OSHEA HOME - MEREMERE RD
PROPOSED ALTERATIONS

Consent No.	040207	Home Phone:	06 272 2852
Consent Issue date	20/04/04	Bus Hours Phone:	
Application date	31/03/04	Fax No:	
Overseer	Owen Steer		
Description	Alterations, Repairs or Extensions Being Stage 1 of an intended 21 Stages DWELLING ALTERATIONS		
Intended Life	Specified as 50 years		
Intended Use	DWELLING		
Estimated Value	\$52,000		
Location	1397 MEREMERE ROAD, MEREMERE		
Legal Description	LOT 1 DP 16180 PT SECS 17 & 18 BLK VIII HAWERA SD		
Valuation No.	1230041400

- Flashing details for all openings and roof planes are to be submitted.
- Post to beam connection details.
- Truss design schedule and truss to top plate fixing details are to be supplied.

Field Inspection Notes:

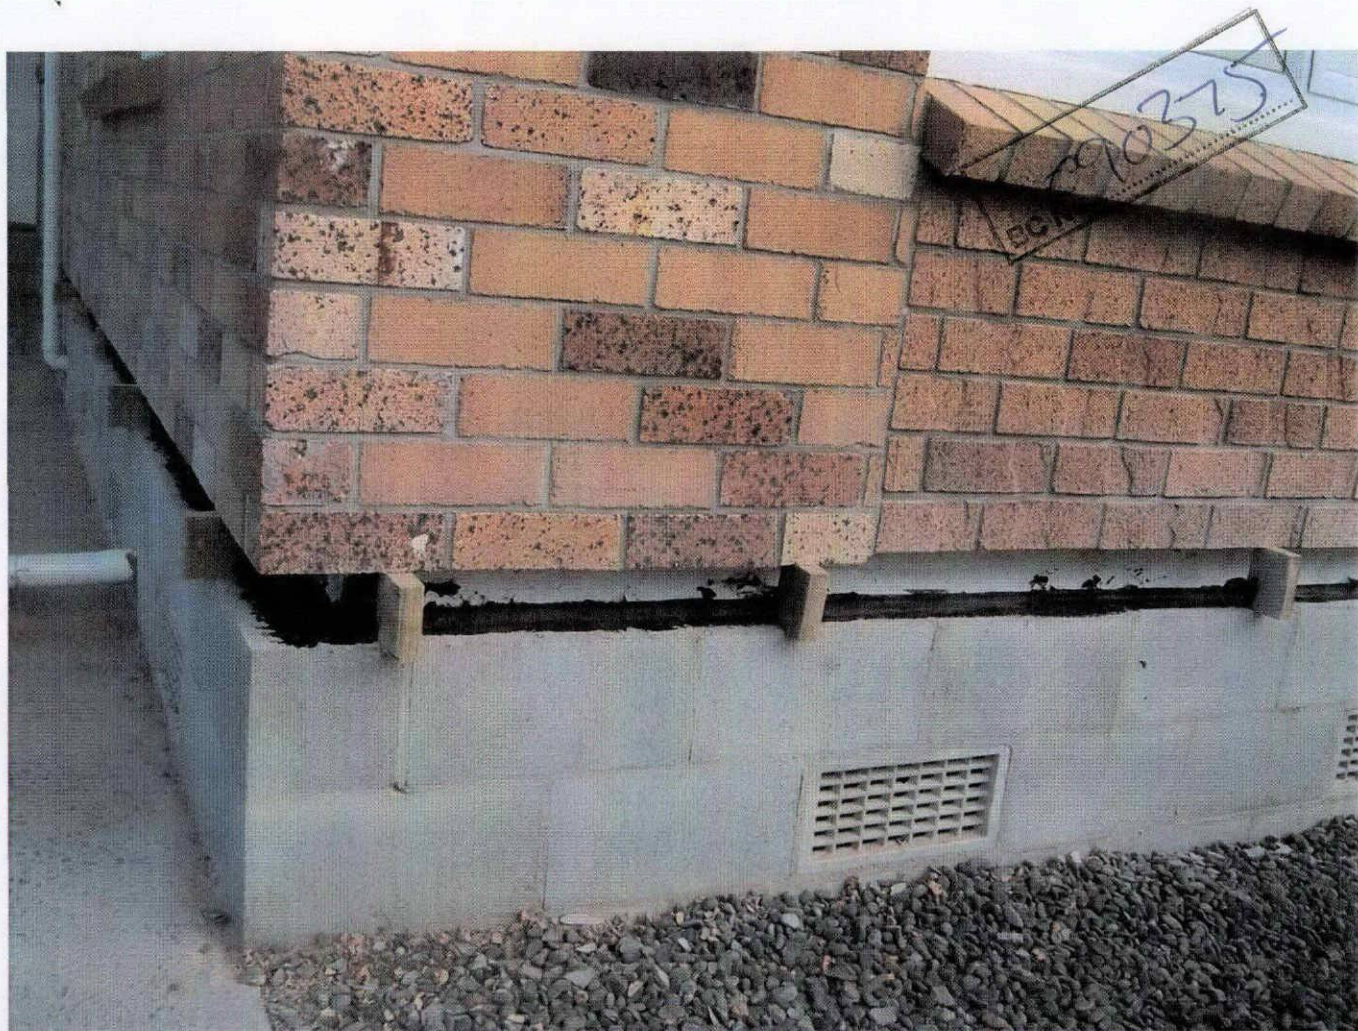
Bricks removed
 Shutter removed
 Tape fitted to AS.
 Ambushed Paul -
 AS requested
 OK to reinstating
 bricks - recheck
 required - on
 completion -

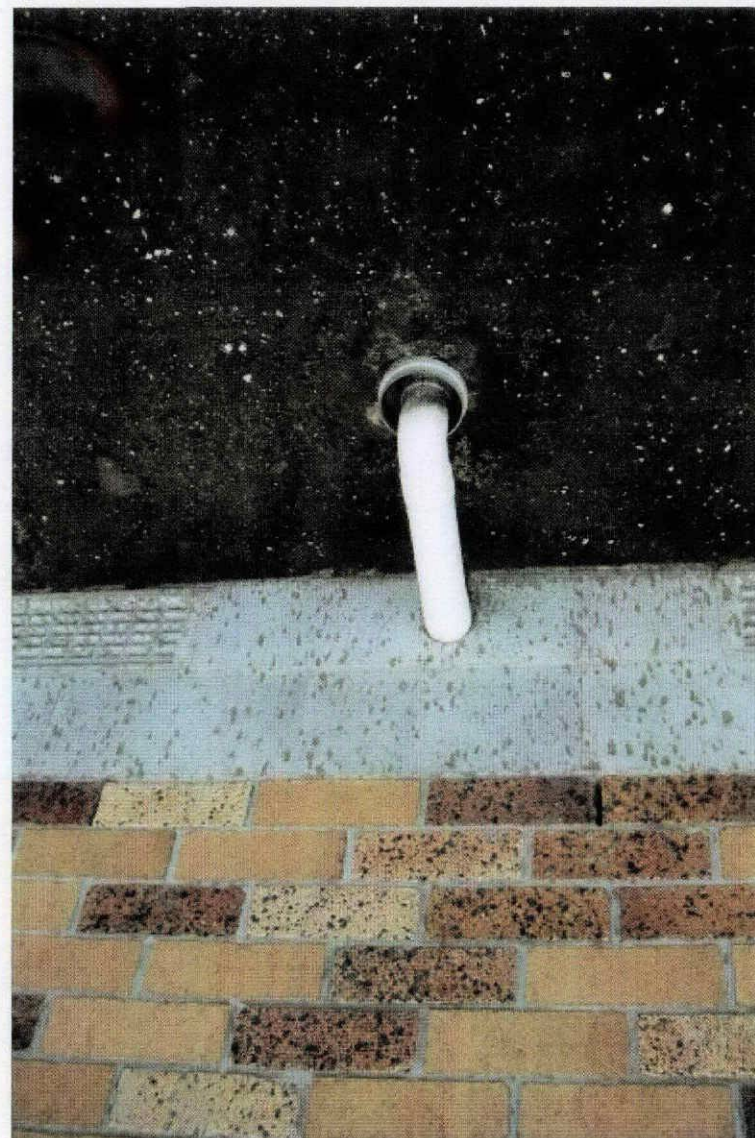
REMOVE GREASE TRAP AND
 COMPACT WITH APPROPRIATE FILL.
 LATERAL STEEL TO BE COMPLETED
 AS REQUIRED TO MEET
 COMPLIANCE.
 RECHECK REQUIRED BEFORE
 POURING.
